SSS-FSAR

QUESTION 312.1

Section 2.1.2 of the FSAR indicates that PP&L owns the entire plant exclusion area. State whether or not this includes the mineral rights. In the event the mineral rights are owned by others indicate the authority to control all activities within the exclusion area.

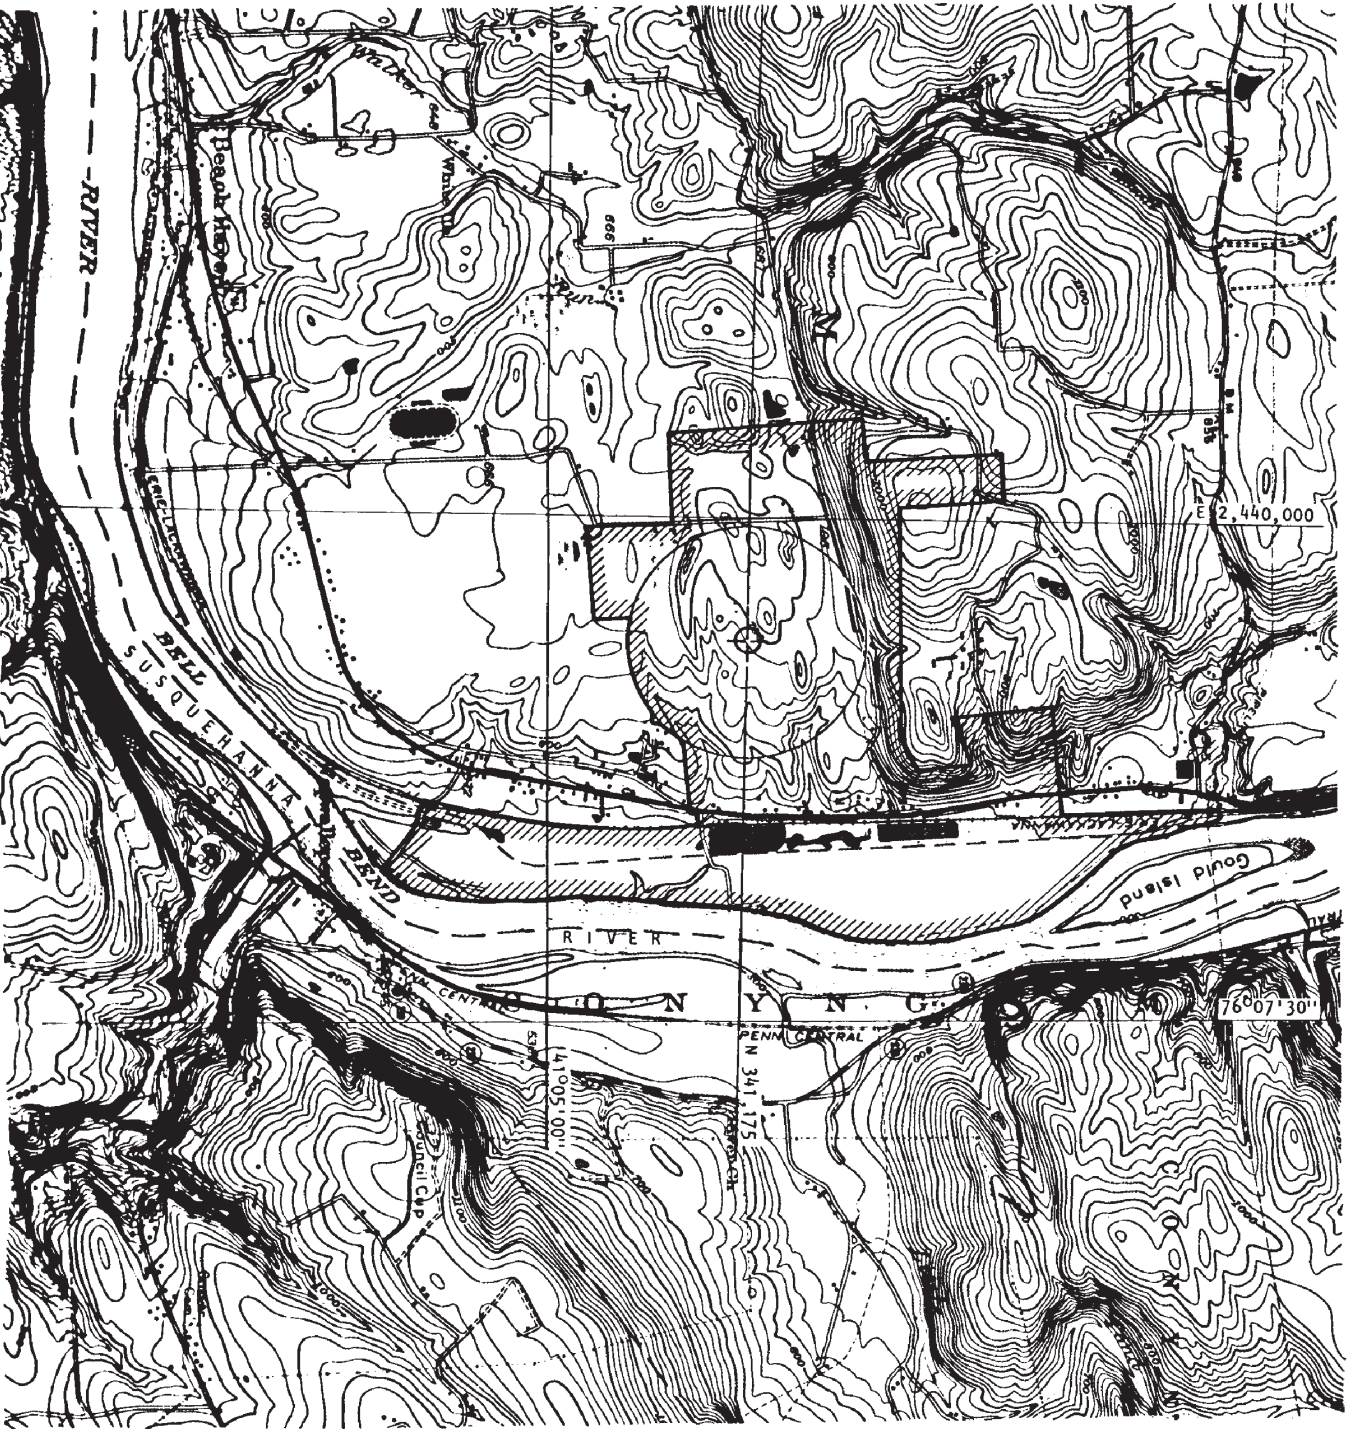
None of the maps in the FSAR clearly show the exclusion area boundary. Provide a full scale section of the USGS map of the Berwick, PA quadrangle which clearly shows the exclusion area as well as the plant boundary. (FSAR Figure 2.1-1 is too small to provide sufficient detail.)

See the SSES Emergency Plan or the Technical Specifications for a depiction of the exclusion area.
